McMILLAN SAND FILTRATION SITE COMMUNITY CENTER & PARK DESIGN UPDATES

COMMISSION OF FINE ARTS SUBMISSION

4 MAY 2023

McMILLAN COMMUNITY CENTER LANDSCAPE DESIGN UPDATE

Figure 14: Updated site plan showing added bioretention. *Note new east-west walk connecting playground to west leg of Olmsted Walk and western portal, paralleling the new bioretention basin.

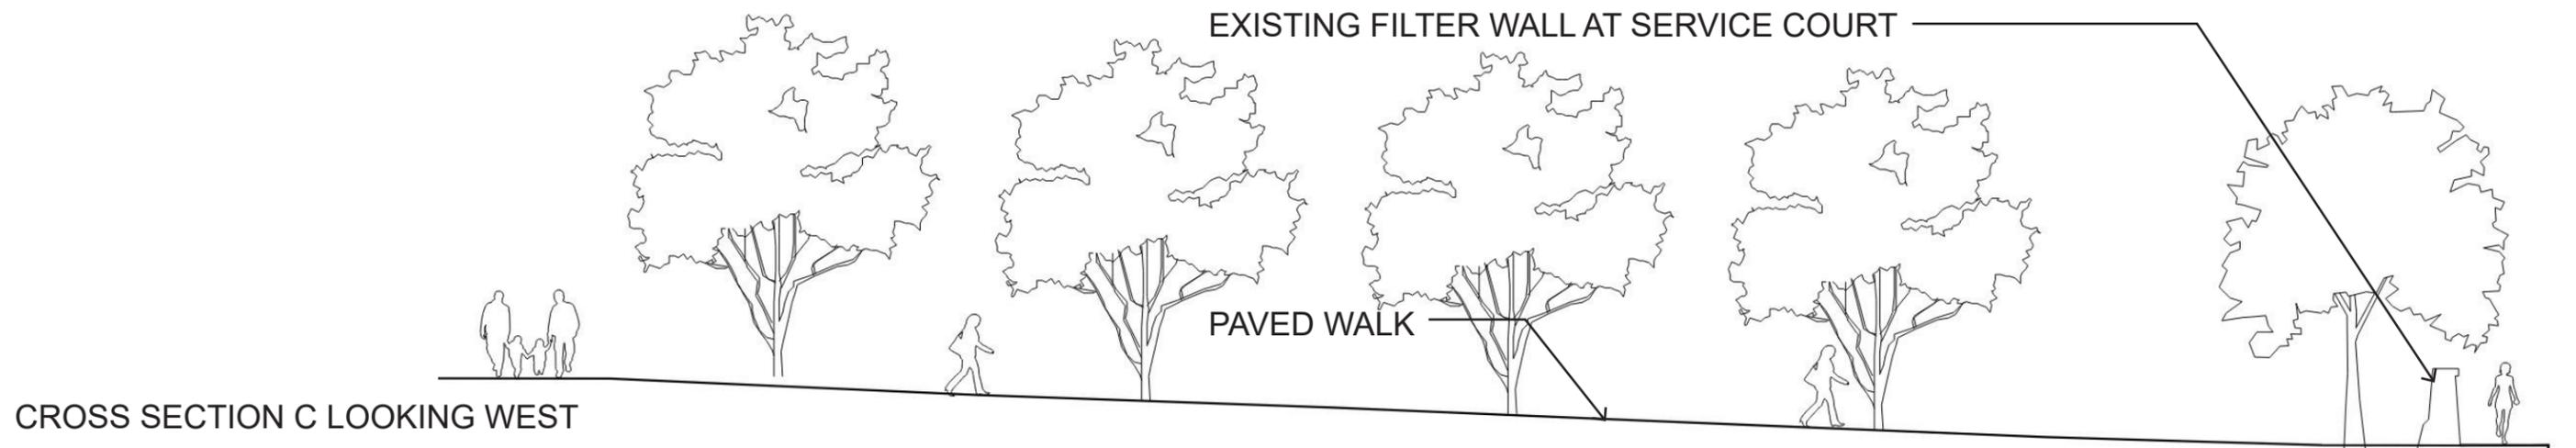
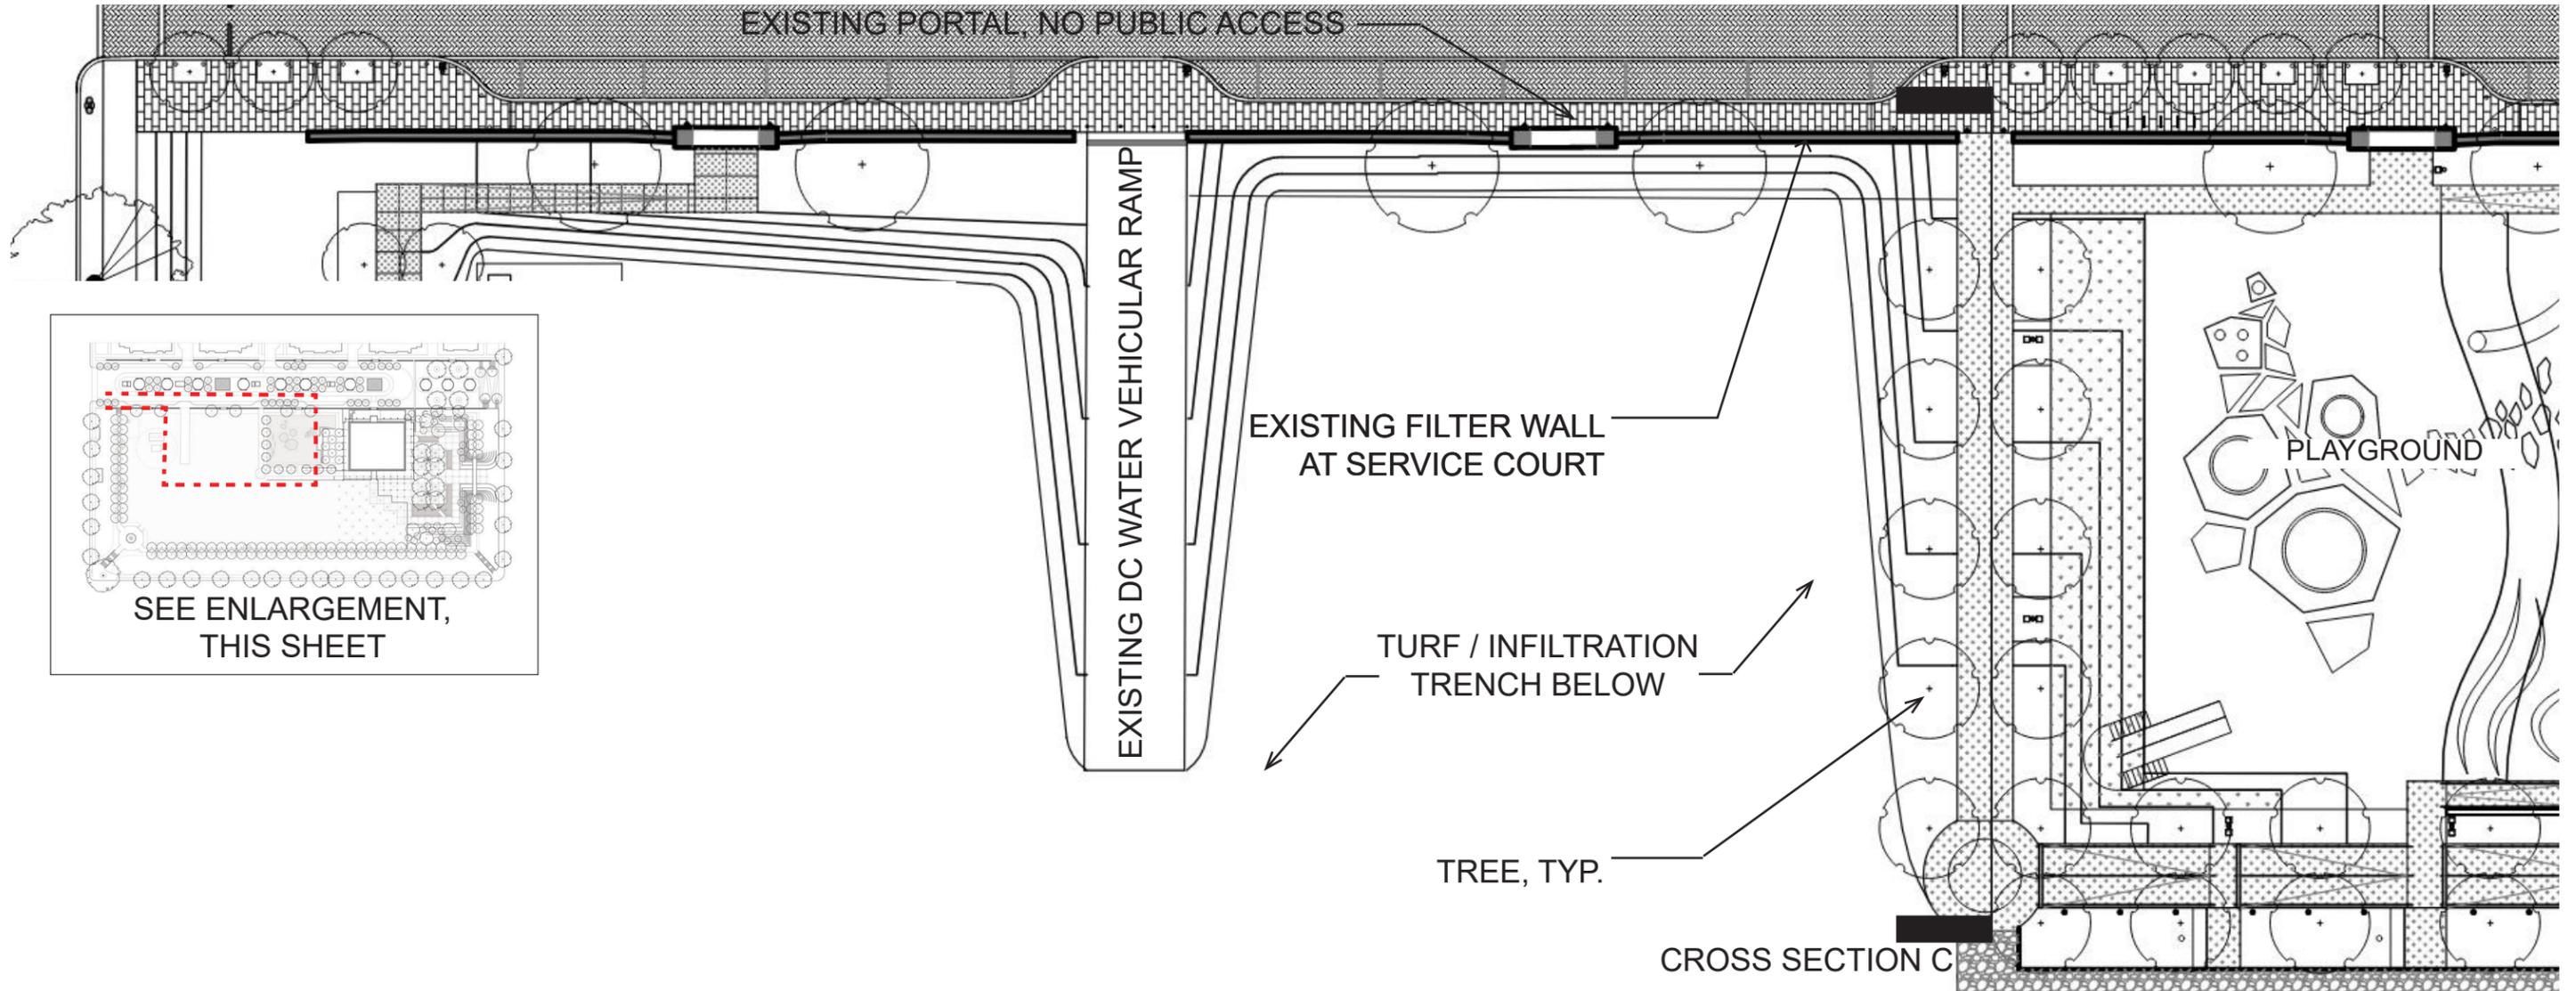
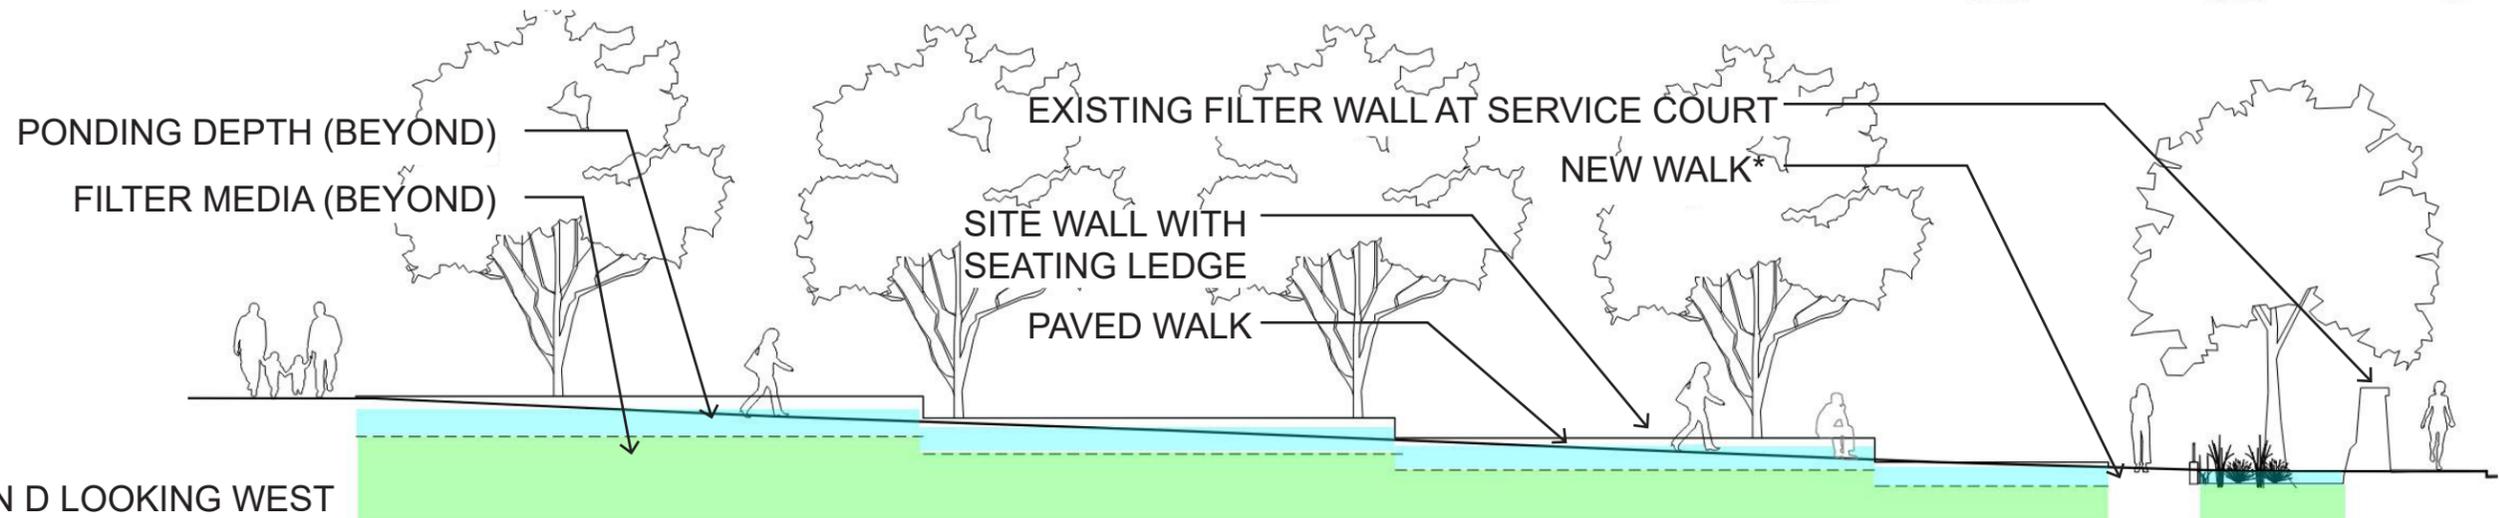
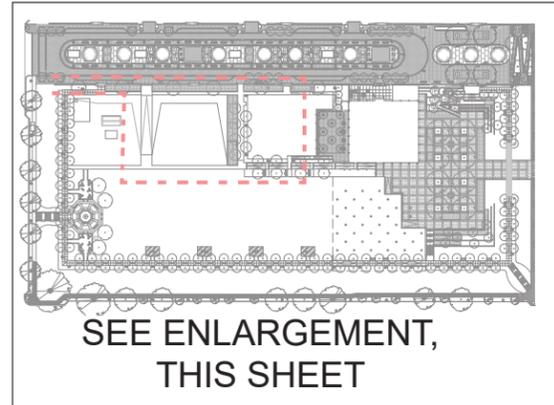
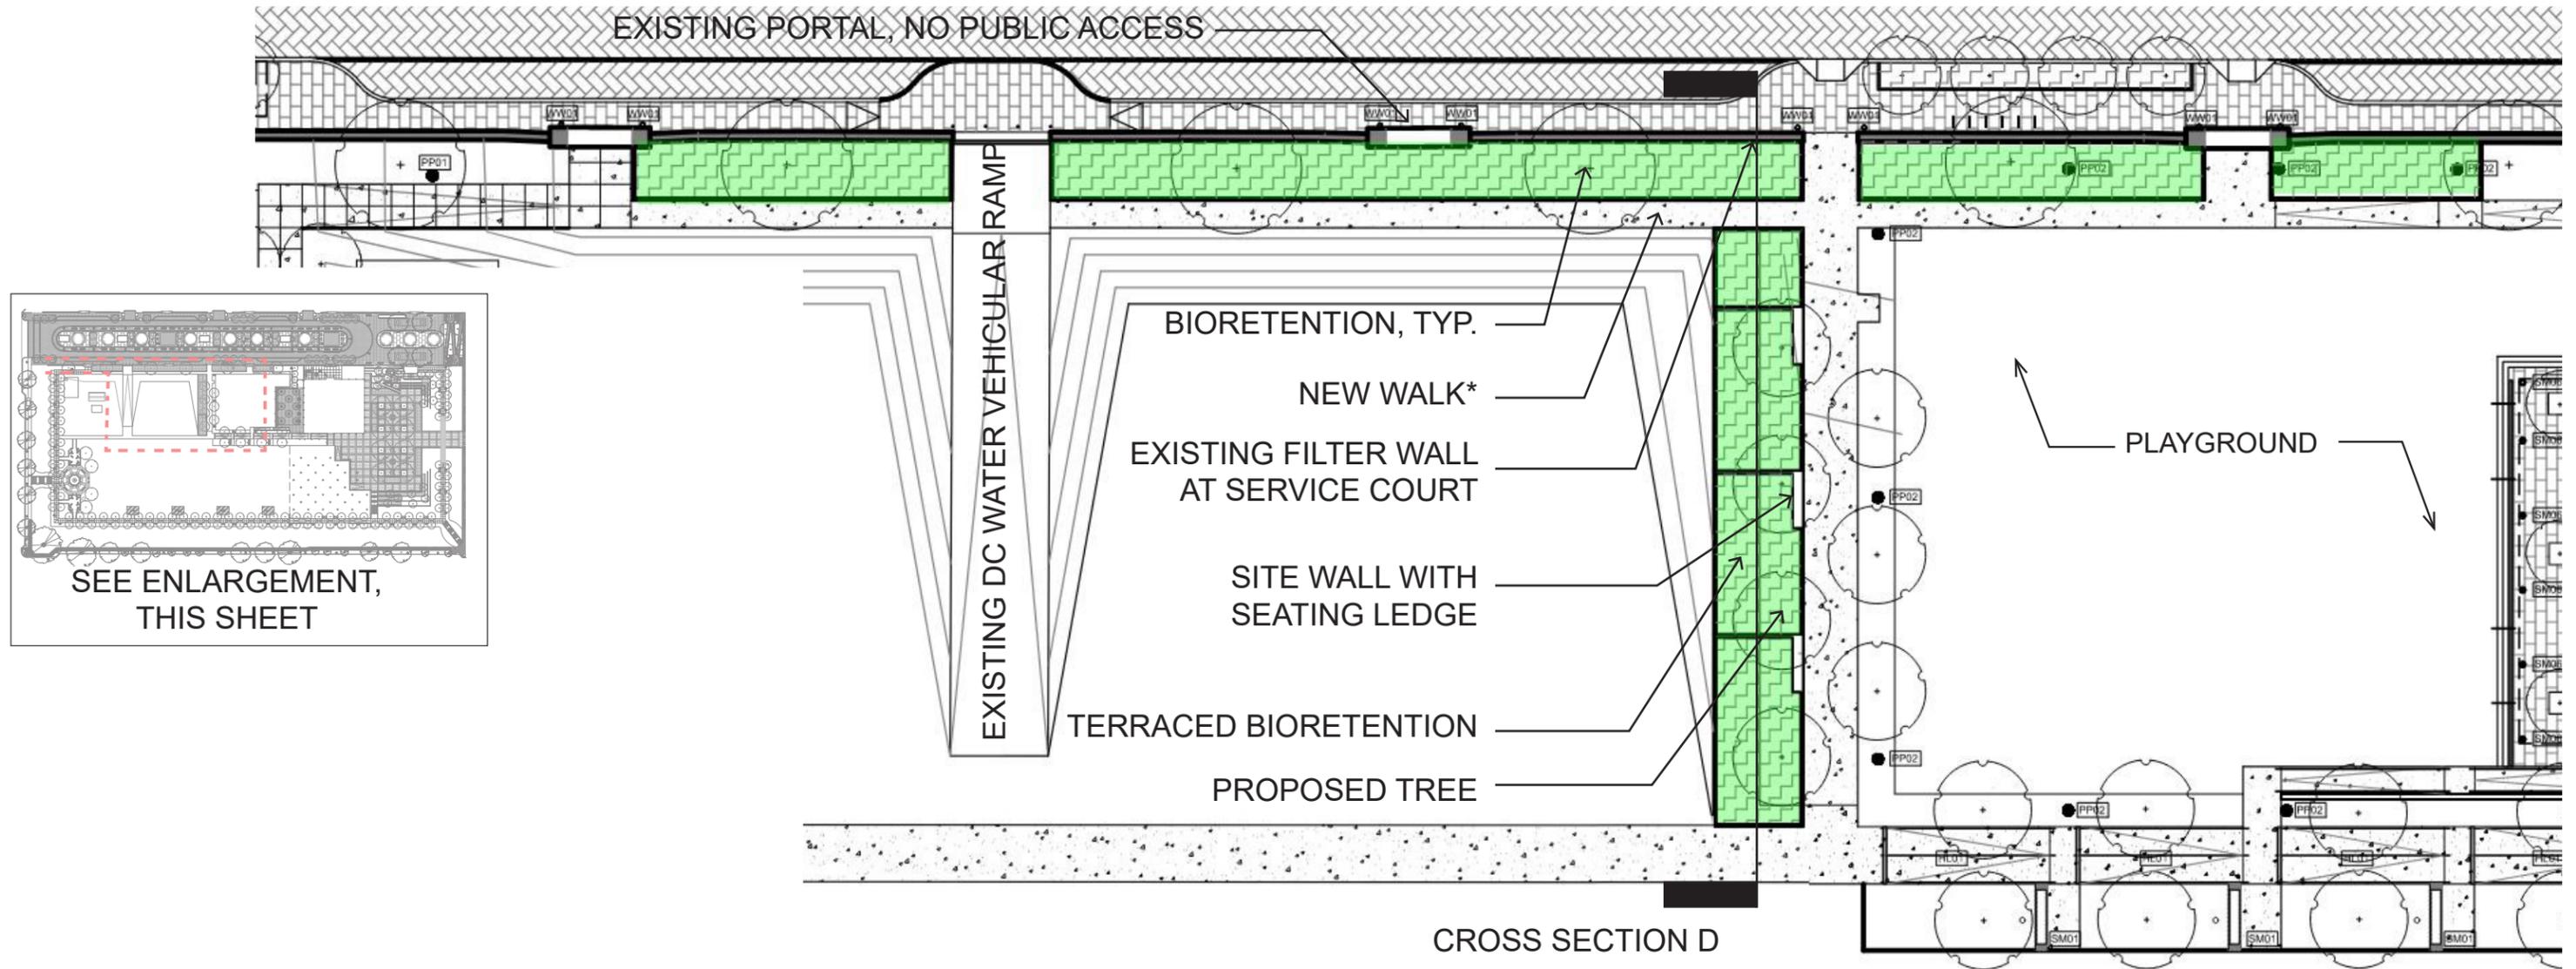
The addition of bioretention features along the South Service Court wall provided an opportunity to create a pedestrian connection from the playground to the Olmsted Walk and westernmost portal.

Figure 16: Updated site plan showing areas of permeable pavers in blue.

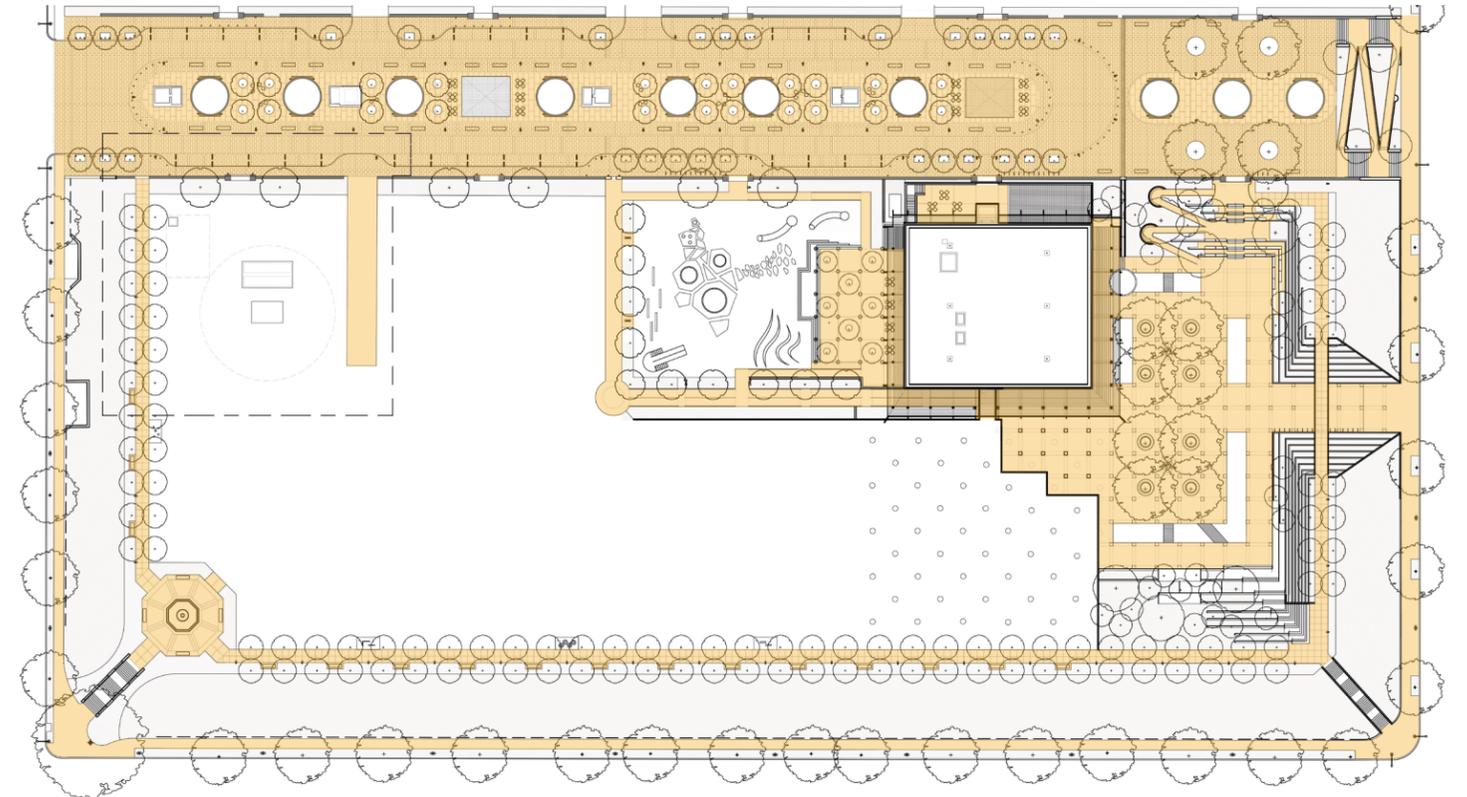
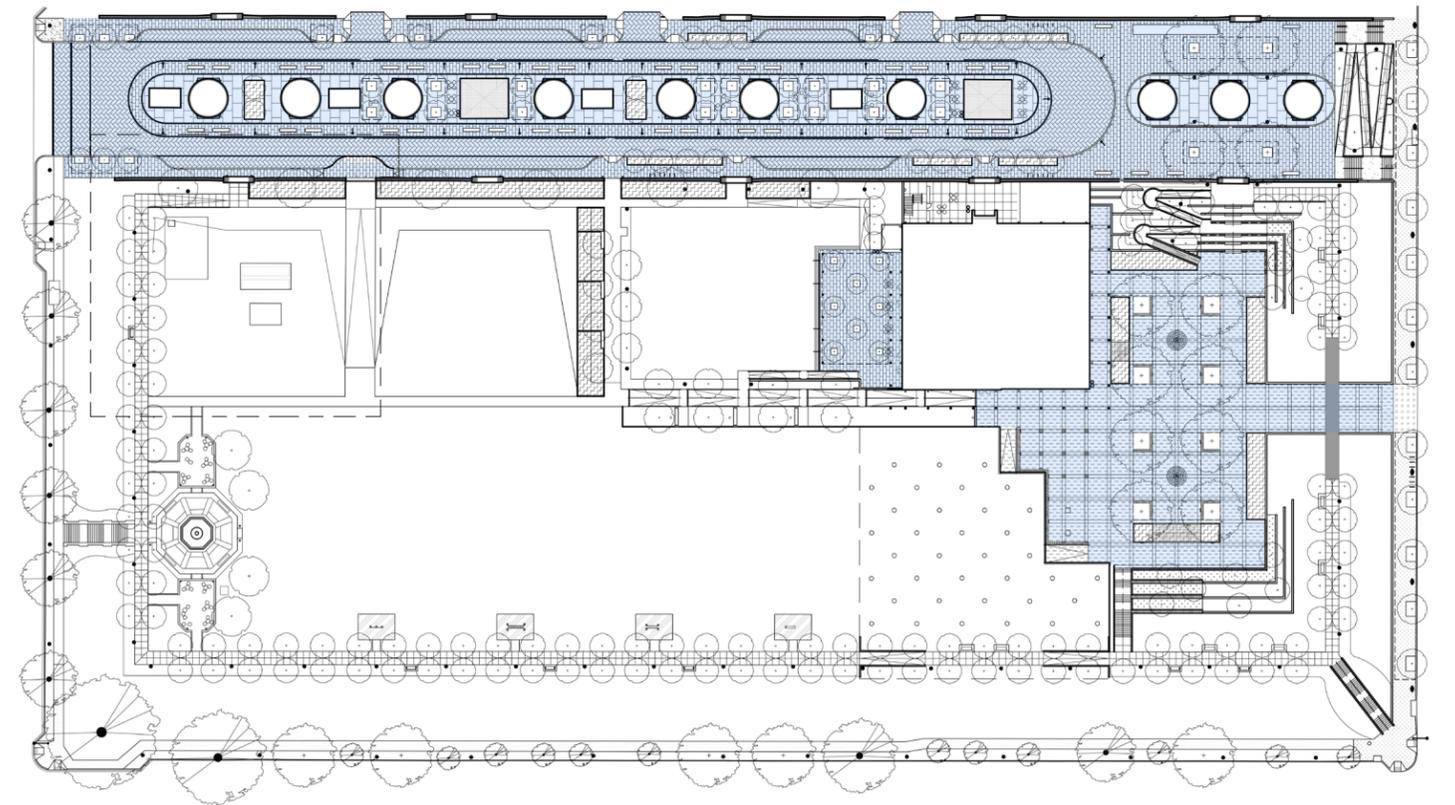
When presented to the Commission of Fine Arts in June 2020, all paving on the site was proposed to be impervious, as shown in Figure 15. Paving comprised cast in place concrete with a few areas of granite pavers in the plaza marking the former locations of filter cell columns.

In order to meet stormwater management requirements, many of the paved surfaces have been updated to be permeable, as shown in Figure 16. The vehicular and pedestrian areas of the South Service Court have been revised to be permeable pavers. Similarly, the paving plan for the plaza utilizes permeable pavers. These are configured using different colored pavers to retain the design intent of identifying the historic filter cell column grid. Because sheet flow from the South Service Court to the proposed runnel in the north part of the plaza would no longer be adequate to activate that feature, it has been removed from the project.

The revision of impervious paving to permeable surfaces increases sustainability of the site and treats most of the stormwater where it falls rather than conveying it directly to the stormwater sewer system.
